APPEAL SUMMARY

Appeal ID: 24414	Project Address: 15045 NE Mason St
Hearing Date: 11/25/20	Appellant Name: Joel Joiner
Case No.: M-001	Appellant Phone: 5038061421
Appeal Type: Mechanical	Plans Examiner/Inspector: Thomas Ng
Project Type: commercial	Stories: 1 Occupancy: F Construction Type: B
Building/Business Name: Avalign- Thortex	Fire Sprinklers: Yes - Ceiling
Appeal Involves: Reconsideration of appeal	LUR or Permit Application No.:
Plan Submitted Option: pdf [File 1] [File 2]	Proposed use: Industrial- Shop

Energy Report

Figure 1: 3D view of model in eQuest

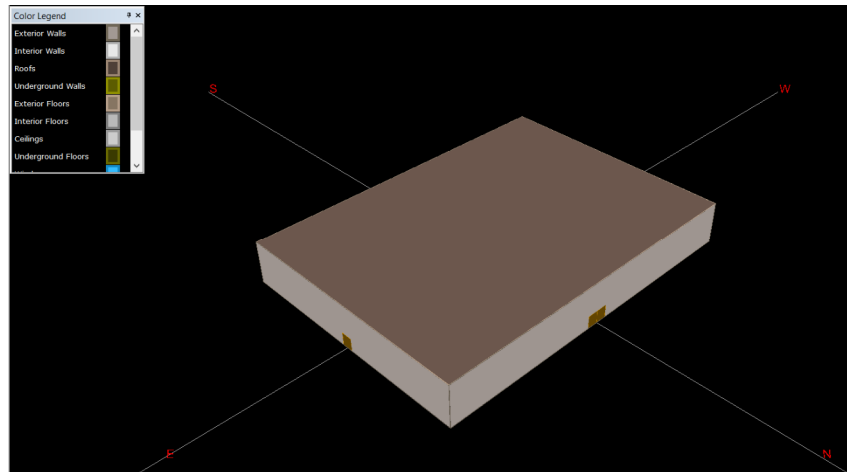
EQuest 3.65 was utilized to perform an annualized energy cost analysis. A baseline model was built with insulation based on Ashrae 90.1 2016. A proposed model was run in comparison without insulation on the exterior walls and with LED lighting. Both models had zero unmet heating and cooling hours.

The manufacturing facility has internal thermal loads from the manufacturing equipment sufficient enough, that adding insulation to the facility walls would trap in more heat than adding insulation would keep out due to conduction.
